Subject: DRH14-00187
2950 E. Parkcenter Blvd.

Project/File: DRH14-00187

The applicant is requesting design review approval for the construction of Barber Station Apartments, a multifamily development consisting of 96 dwelling units, one clubhouse, garage parking and surface parking on approximately 4 acres.

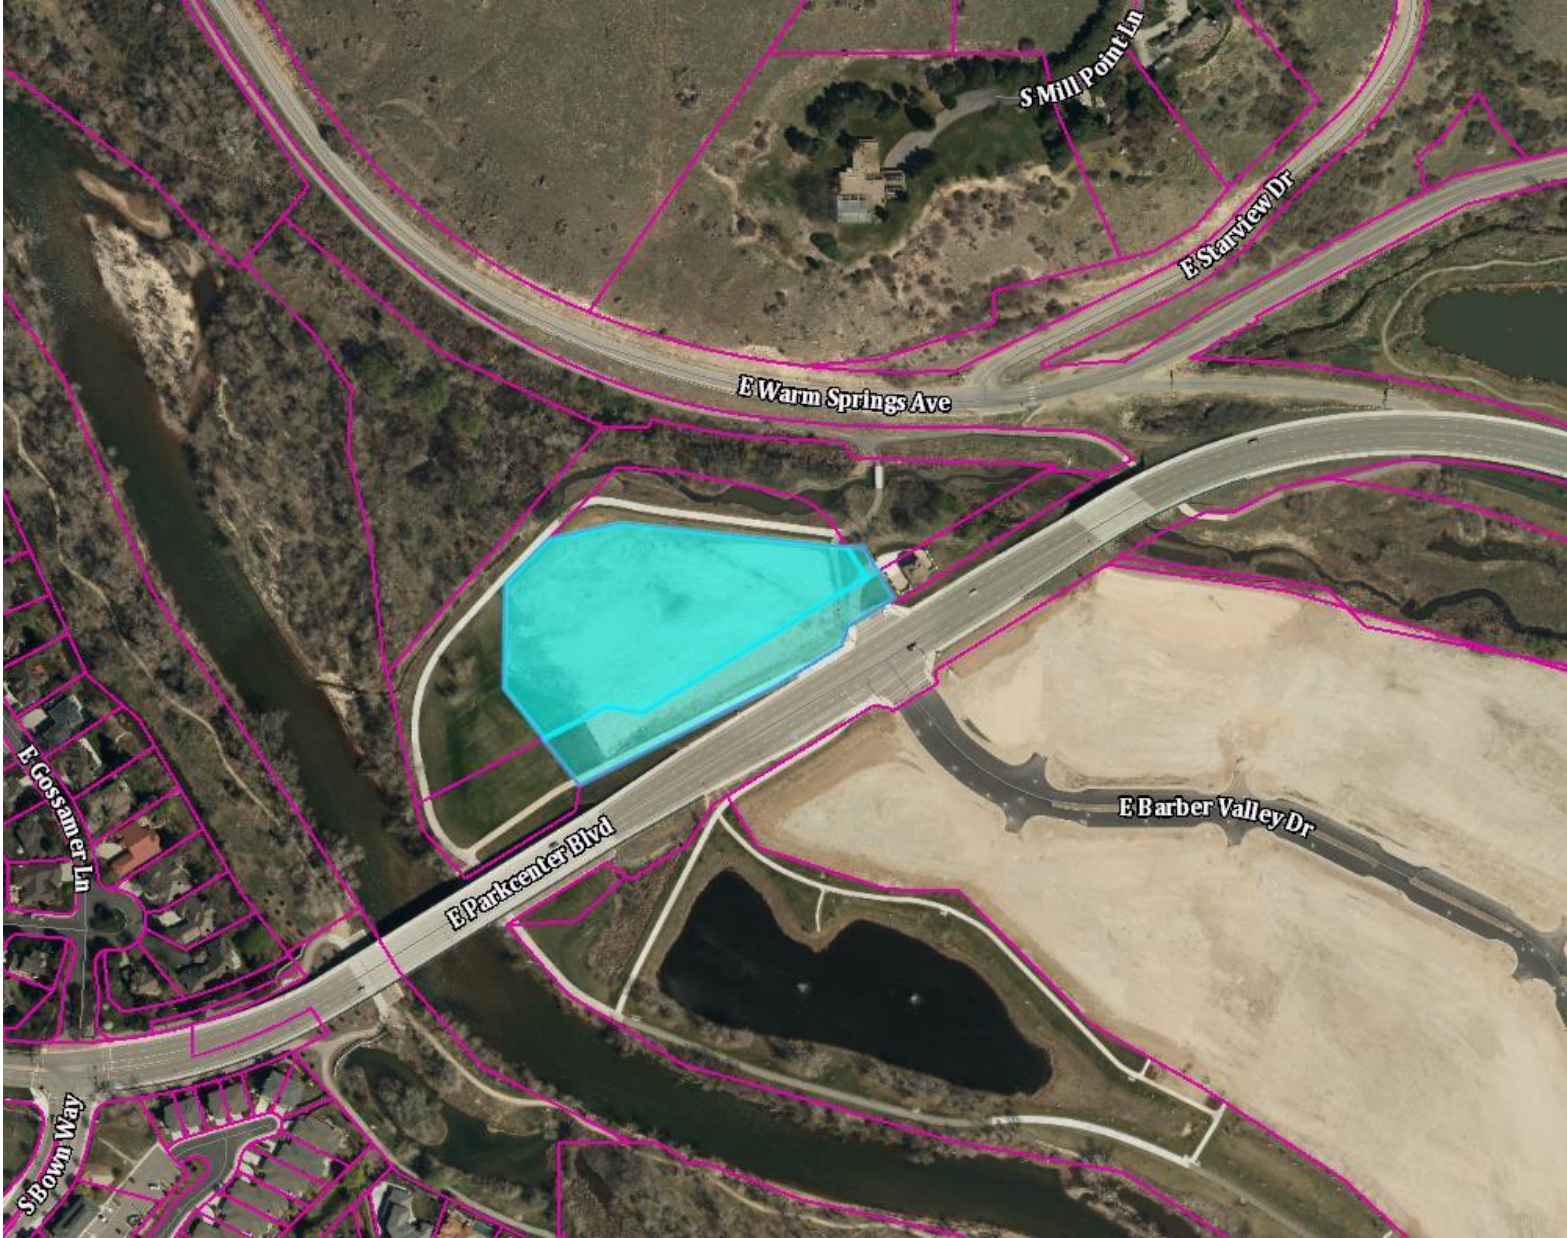
- c. **Applicant's Proposal:** The applicant is proposing to utilize the existing driveway approach from the site onto Parkcenter Boulevard, with a drive aisle intersecting the driveway just north of Parkcenter Boulevard.

- d. **Staff Comments/Recommendations:** The drive aisle as it intersects the driveway should be reconfigured. As proposed, vehicles exiting from the drive aisle to the driveway will not have sufficient room to be detected by the future signal. This intersection is planned for future signalization to accommodate development on the south side of Parkcenter Boulevard. The drive aisle should be shifted to the north to achieve a greater offset from Parkcenter Boulevard.

1. Reconfigure/modify the location of the drive aisle where it intersects the existing driveway. The drive aisle should be located as far away from Parkcenter Boulevard as possible to allow for vehicle detection with the future signal.
2. Payment of impacts fees are due prior to issuance of a building permit.
3. Comply with all Standard Conditions of Approval.
